YARRA CITY COUNCIL

Internal Development Approvals Committee

Item		Page	Rec. Page
1.1	PLN18/0021 - 1A/2 and 1E/4 Mansard Lane, Collingwood - The sale of liquor for the consumption on and off the premises in association with a food and drink premises (cafe) and a convenience shop (deli).	5	22

1.4	PLN17/0973 - 12-14 Green Street Cremorne - Demolition of the existing dwelling on 14 Green Street (including part of this dwelling located on 12 Green Street) and construction of one new dwelling on 14 Green Street	201	223

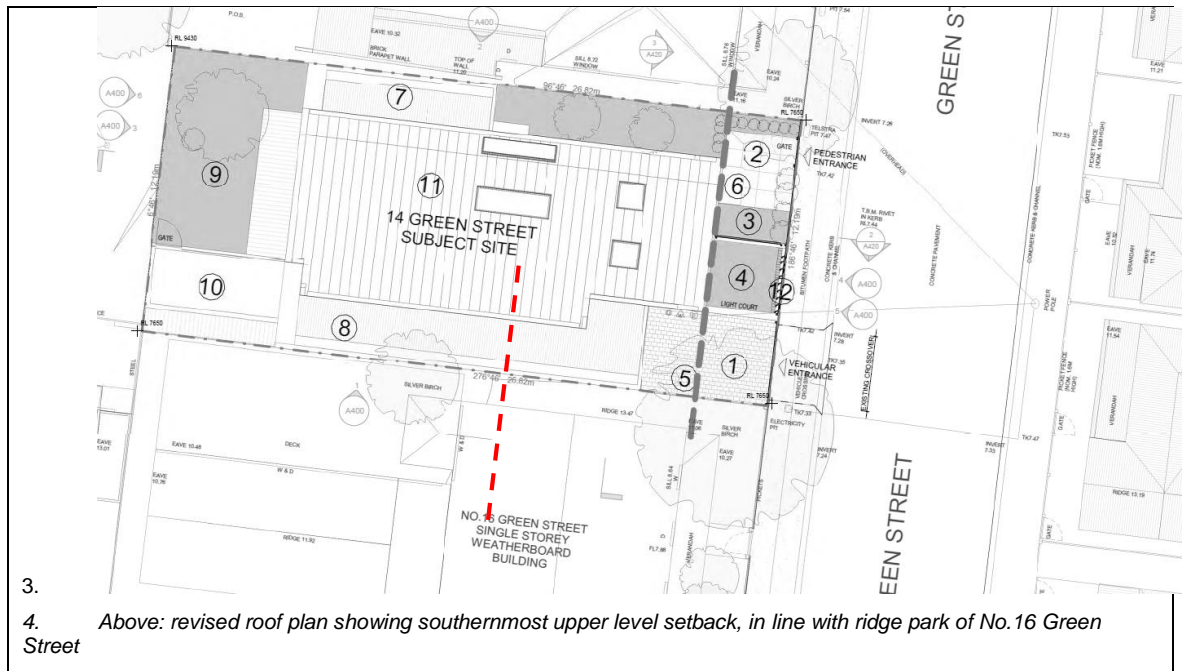
- i. *Reduce the breadth of the new building by modifying the currently proposed side setback of about 2 metres at ground level along the northern boundary of the site to a depth of at least 13 metres from the front boundary (which matches the depth of the side setback for no. 12 Green Street);*

1. The above recommended northern side and front setbacks have been achieved with the new proposal.
2. The southernmost portion of the upper level has a *decreased* setback from street front, by about 500mm. The setback is in line with ridge peak of No.16 Green Street and is supported.

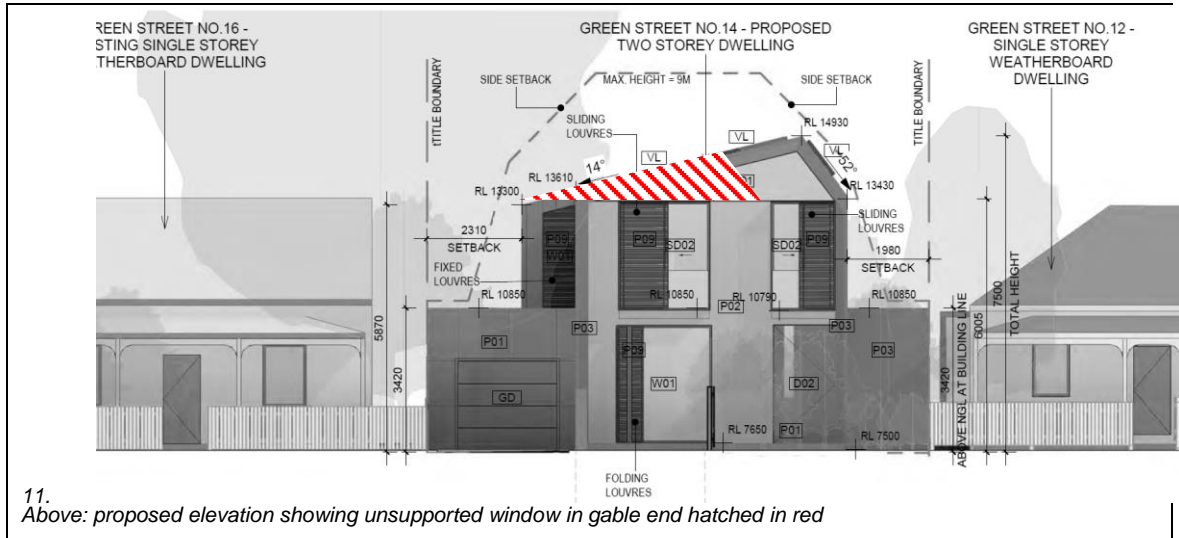
10. The above recommendation has been achieved, except for the glass window in the gable end. The newly proposed appearance of the development is supported only with deletion of this window.

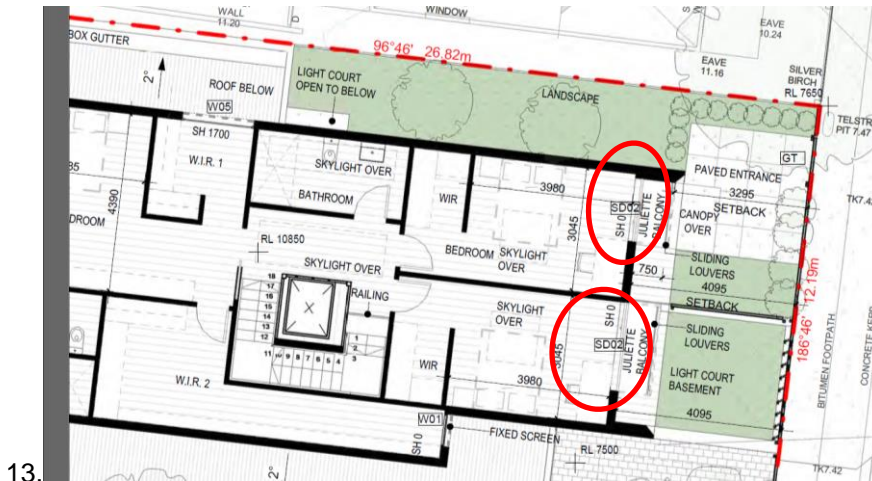
12. When open, it is noted that the proposed folding louvres at the front will project forward of adjoining contributory buildings, and expose balconies on the front façade (refer to image below). As a new contemporary infill building, it is considered that this detail is acceptable, as the projecting louvres are not indicative of additional floor space.
